PIMA COUNTY
PROCUREMENT DEPARTMENT
DESIGN & CONSTRUCTION DIVISION • 130 W. CONGRESS STREET, 3RD FLOOR • TUCSON, ARIZONA 85701-1317
TELEPHONE (520) 724-3731 • FAX (520) 724-4434

ADDENDUM NO. 4

SOLICITATION NO. 220377 PANTANO WASH BANK PROTECTION AND RIVER PARK PHASE III: TANQUE VERDE ROAD TO FORT LOWELL PARK (5PWFLT)

(ATTACHMENT 1) (1 PAGE)

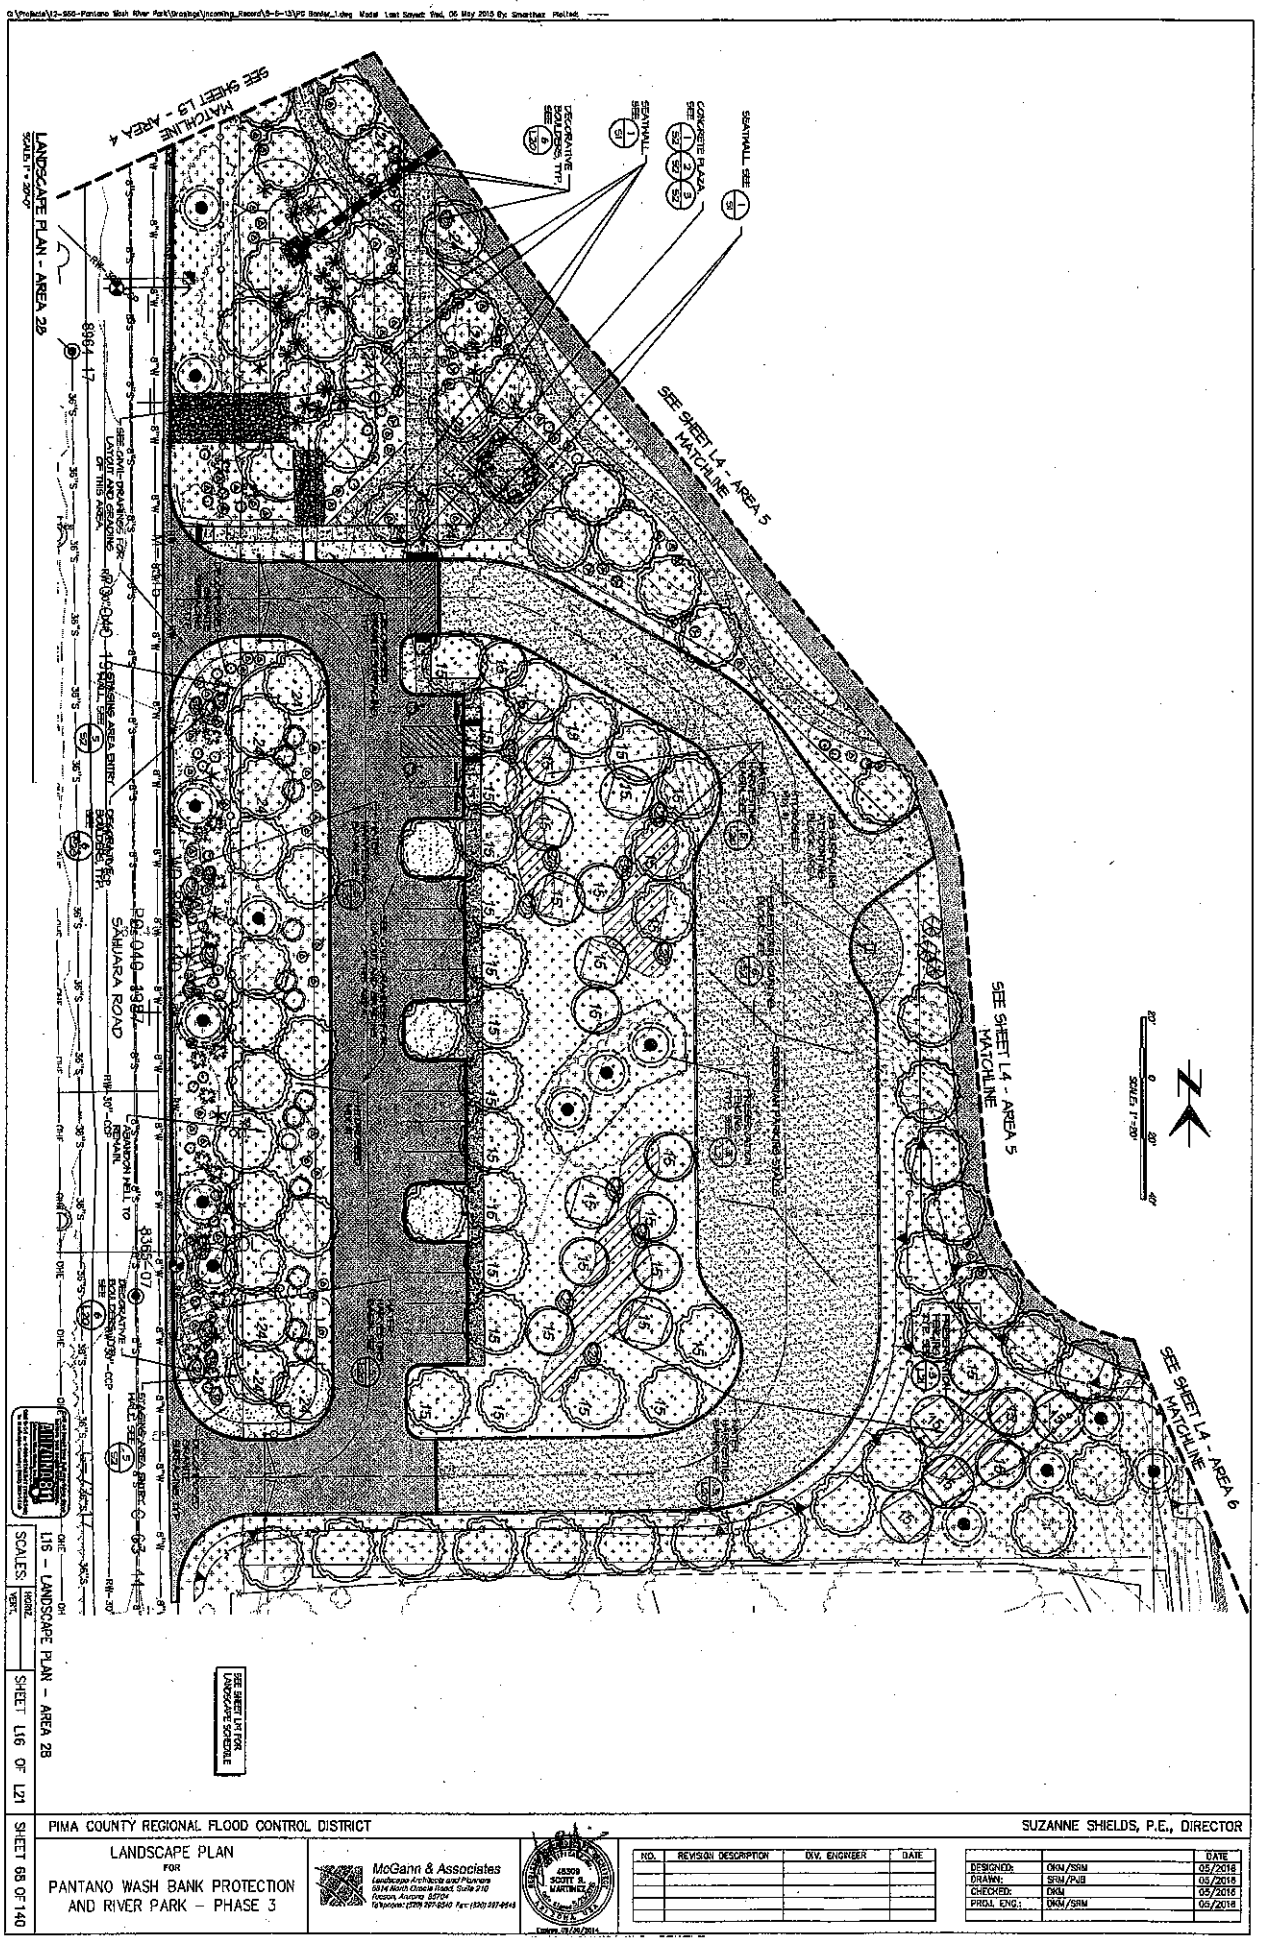
a. Replace Landscape Plan Sheet L-16 (68 of 140) with the attached drawing for the location of the 24" box trees and referenced in the revision box "Addendum #4 - 24" Box Trees, dated 6/23/16". (ATTACHMENT 1)(1 PAGE)

(ATTACHMENT 2) (3 PAGES)

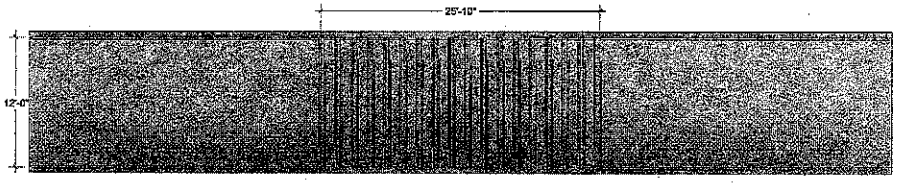
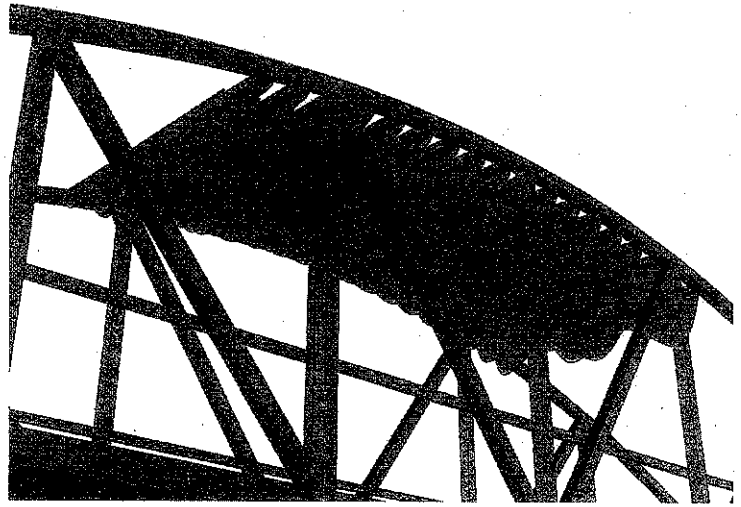
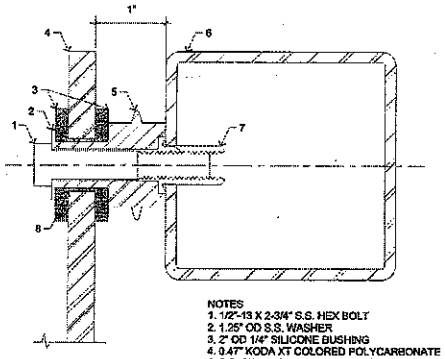
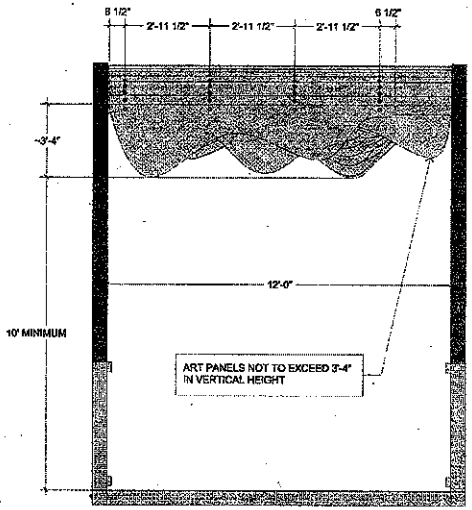
1. Q) Sheet PB3 (106 of 140), Detail 1 – Bridge Sections, states to see Artwork Drawings for additional details of the artwork. Upon review of the plans and the sheet index, Artwork Plans do not seem to be included. Can you please provide these plans? The depth of the artwork is required to determine the radius of the top chord. Additionally the load of the artwork panels will require in order to adequately price the bridge structure.

A) *See Attachment 2- Artwork Drawing and material specification for Contractor information only; the information provides additional details regarding the artwork. The Artist will provide and install the artwork as depicted in Attachment 2. The construction contractor is to provide the bridge as noted in the plan sheets PB1 to PB3. The artwork consists of two panels per beam plus associated hardware; the Artist estimates the weight of the artwork plus hardware to be 275 lbs. per beam.* (ATTACHMENT 2) (3 PAGES)
